INVITATION TO BID NO. 21-DPR-ITB-673

ADDENDUM NO. 2

Arlington County Invitation to Bid No. 21-DPR-ITB-673 for Construction of Thomas Jefferson Upper Field Turf Conversion is amended as follows:

C-15B
SHEET 19 OF 42

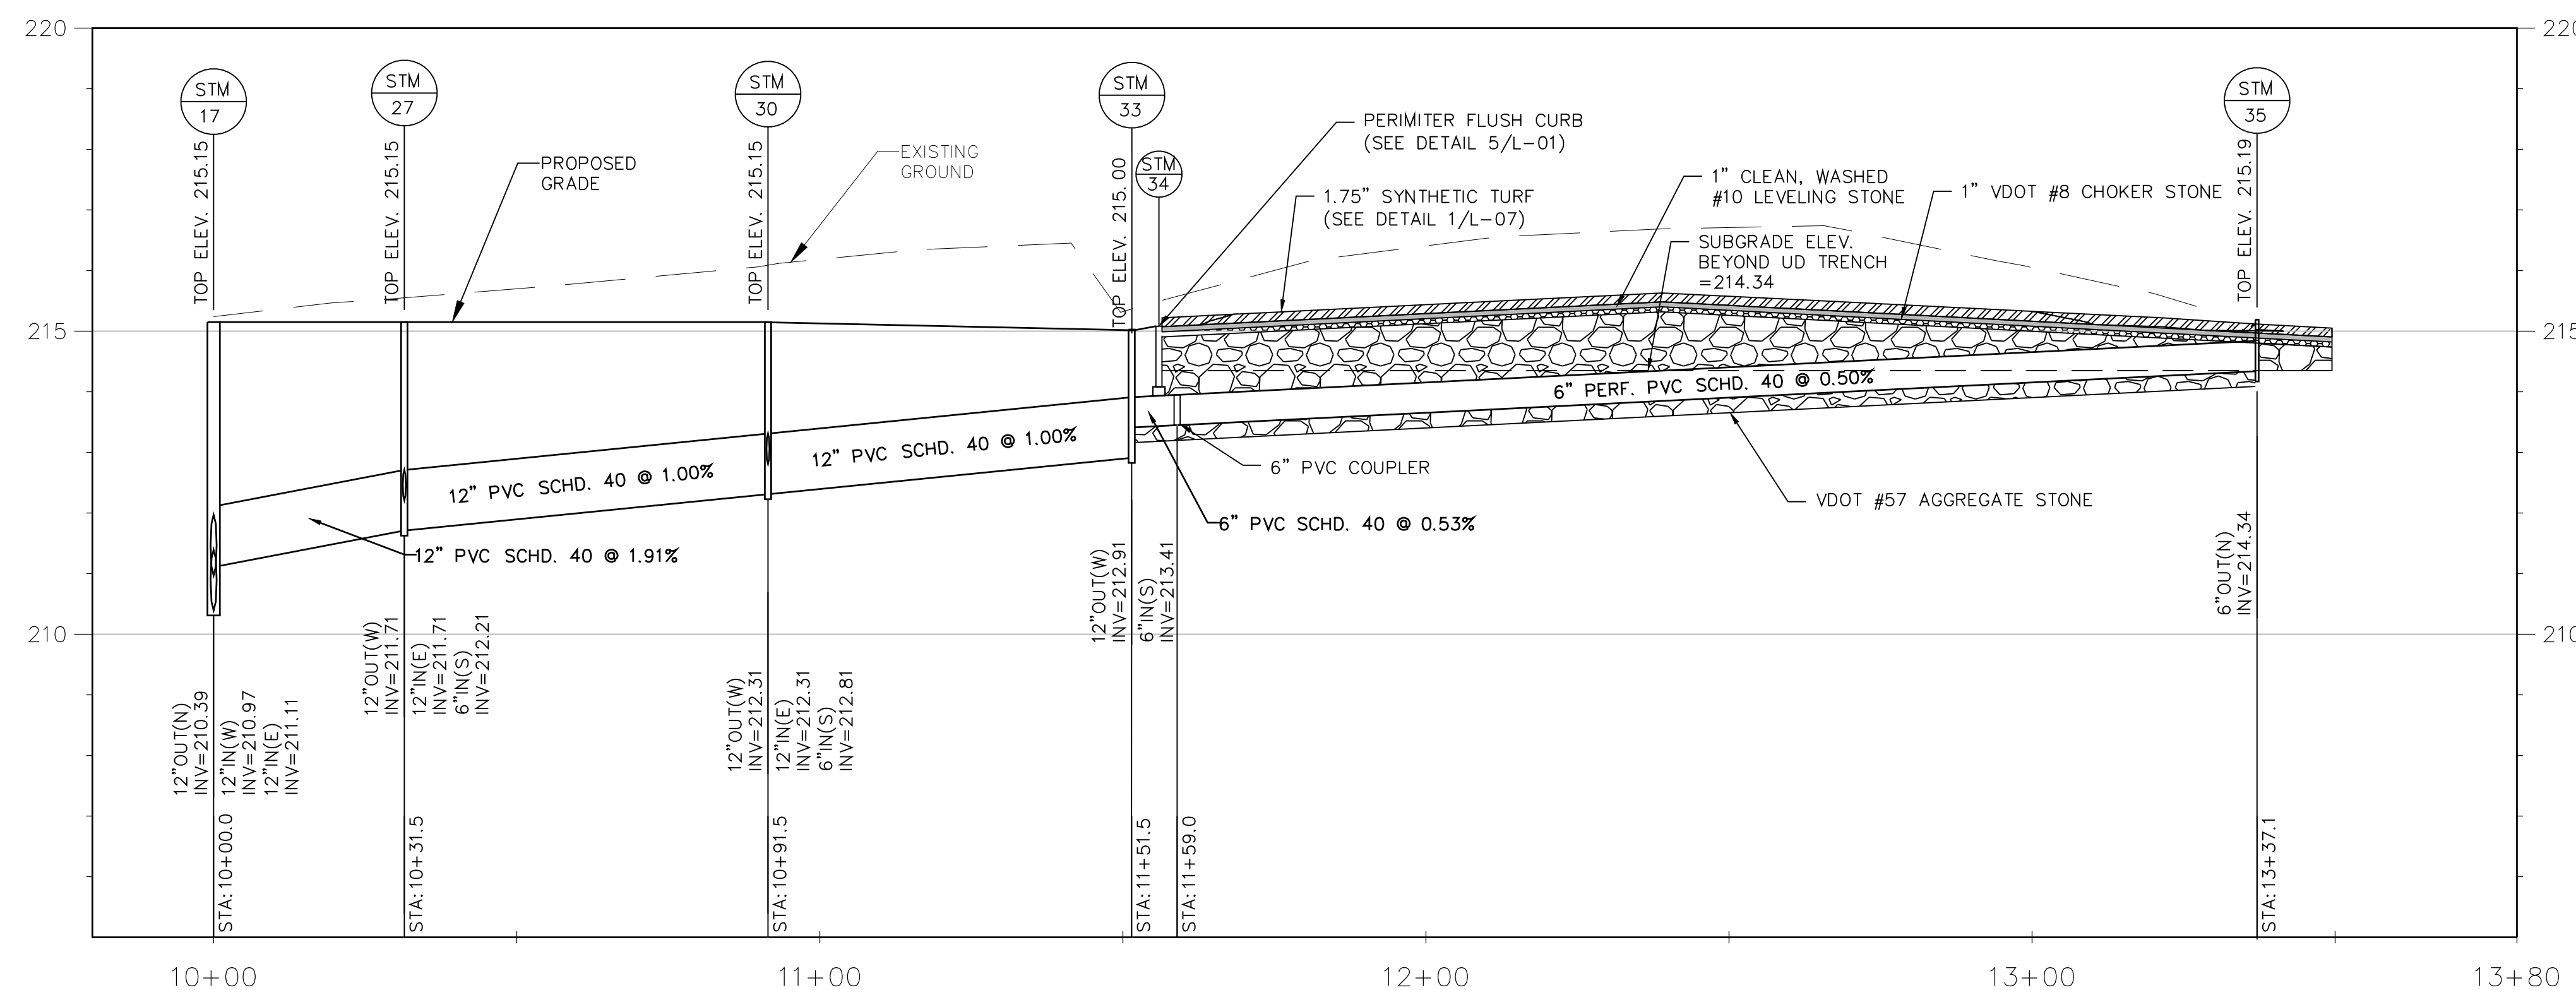
6. **Question: Drawing C15 to C15B have "???" symbols on the storm structure profile and do not identify the storm structure's locations. Please provide drawing for the storm structure profiles and locations.**

Answer: Sheets C-01, C-04, C-11, C-15, C-15A and C-15B have been revised. See attached (Attachment D - Addendum 2 Plans.pdf)
